Subject: Service Station #21485 1132-1144 Forest Avenue Portland, Maine

HEARING ON APFEAL UNDER THE ZONING ORDINANCE OF Phillip's Petroleum Go.

Permit to construct a 1-story mesonry service station building 29'x49' is being issued based on revised plans and specifications received June 12, 1964 but subject to the following conditions:

Check against Zoning Ordinence and Building Code requirements of plans for proposed two-bay service station at the above maded location in this City discloses the following questions as to compliance with those requirements:

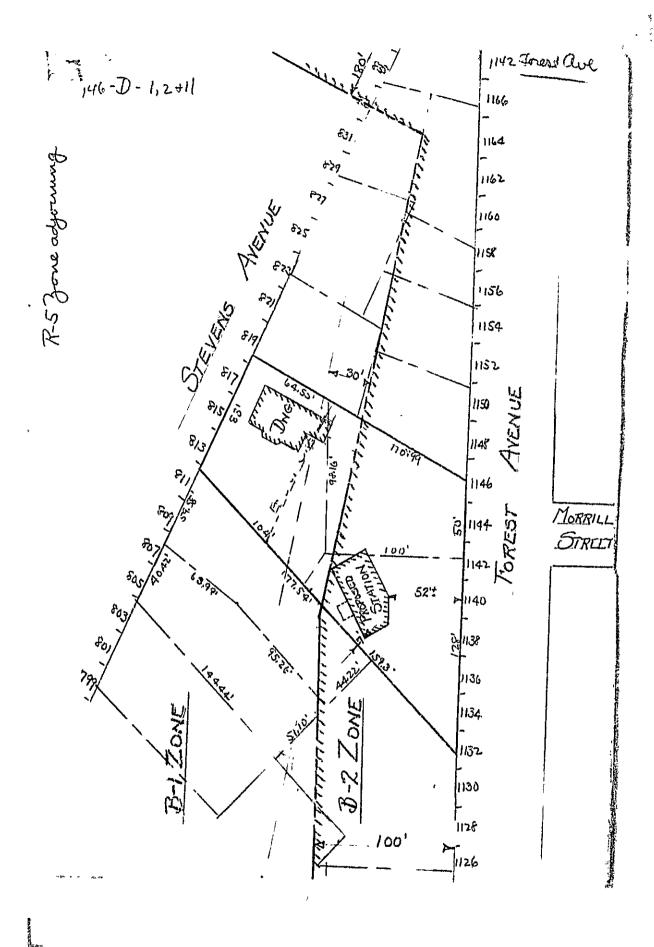
- 1. Since the rear area of the let which abute Stevens Avenue is in a Bal Business Zone where a service station is allowable only as a conditional use, the area to be occupied by the preposed use may not extend more than 30 feet beyond the zone line between the B-2 and B-1 Zones in which the property is located, Area indicated for surfacing on plot plan filed extends beyond that limit. Neither will it be paraisable, if desired, to have a driveway from Stevens Arrange to the service station area.

- 2. In the B-2 fore the height to top of the detached sign is limited to 20 feet. Flashing or in wmittent lighting is not allowable.
- 3. The door in the rear wall of building is required to be a labelled fire door because it is to be located closer than 30 feet to a lot line.—Ess Section 201-b-2 of the Building Code.

- 4. An approved grouse and oil esparator is required in line from floor drains to public sewer. See Section 201-1-1.
- 5. The unsupported height (from grade to bettem of roof jaiets) of the 6-inch concrete block walls of higher section of building will exceed the maximum allowable of 12 feet set by Section 309-b-3 of the Code. I. a poured concrete foundation wall were to be used instead of the concrete block wall shown below grade, this foundation may extend to a height of not more than 3 feet above the grade and the unsupported height of the superstructure wall measured from the top of the concrete wall, as provided by this same section of the Code. Now will you care for this cituation?

- 6. Support of wooden roof joiets on the cloping ourfees of flanguard Wall, steel beams as indicated for roof and carefy framing it ant alterable word under the provisions of feeties 312-0-3.2(ii) of the Code.

7. Details are needed chowing construction where canopy joins walls of building since the arrangement is to be different from that shown on standard plans filed.

- 8. The projection of concrete floor of building continuously as an apron boyond the foundation wall of the building so as to be newedy subject to frost action is questioned. A statement of design (blank copy enclosed) signed by a qualified person is needed for affixing to the plans.

Pormit for construction of building cannot be issued until information indicating compliance with above requirements has been furnished.

### FLOOR FRAMING

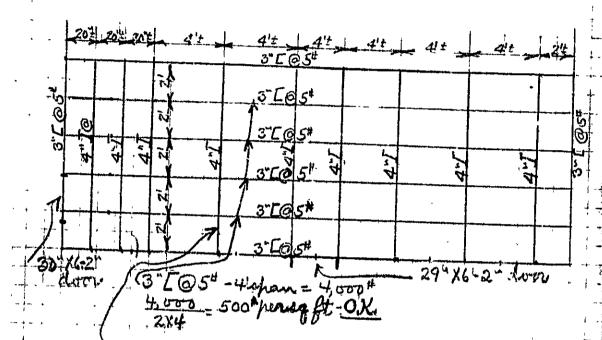
4"I@ 7.7#-9than = 4400# 4400 122 person ft. O.K

1- Sheding doors probably O. X. since not more than
50 people involved.
2 - Hooks only 29" wide X6'2" high where 36" width
3- Unable to see study but from Unickness of wall
doubt if their can be more than 2X3. From sounding
of wall board spacing appears to (224" or more on
through occurs entire voof construction appears to be
forwerd occurs entire voof construction appears to be
brout to deep. Probably new wring required.

Ilout think building comples with Code requirements so don't see how we can usue hermut to more it into City.
